# Service Bulletin

Bulletin No.: PIT6302A

**Subject: Rubbing / Scraping Noise When Turning The Steering Wheel**

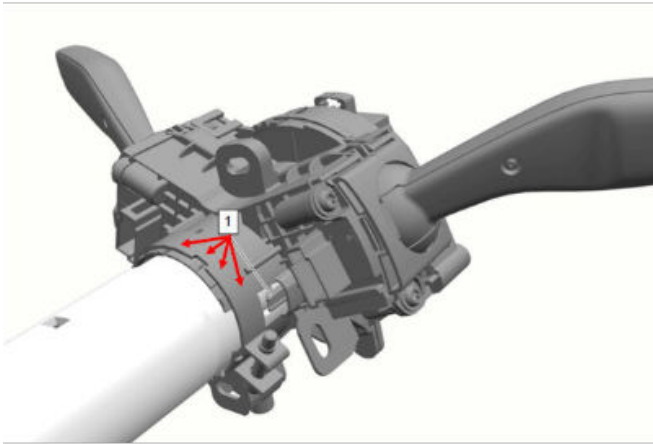
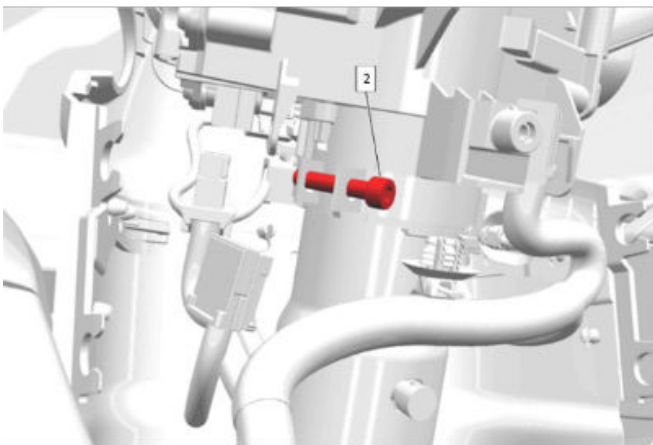
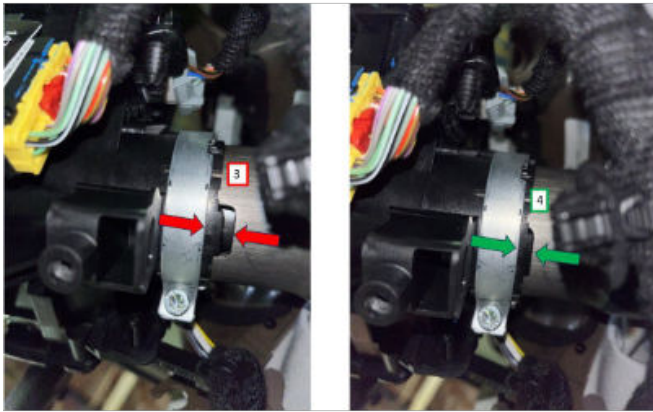
<b>Involved Region or Country</b>	North America
<b>Condition</b>	Some customers may comment on hearing a rub or scrape noise when turning the steering wheel left or right.
<b>Cause</b>	The noise could be the steering column trim covers contacting the steering wheel due to the turn signal switch bracket (1) not fully seated/installed onto the column tube, shown below (3).

To correct this concern, loosen the turn signal switch bracket band clamp bolt (2) and then fully push the turn signal bracket onto the steering column tube until it is fully seated, as shown below (4). Reassemble and test to verify the noise is gone.
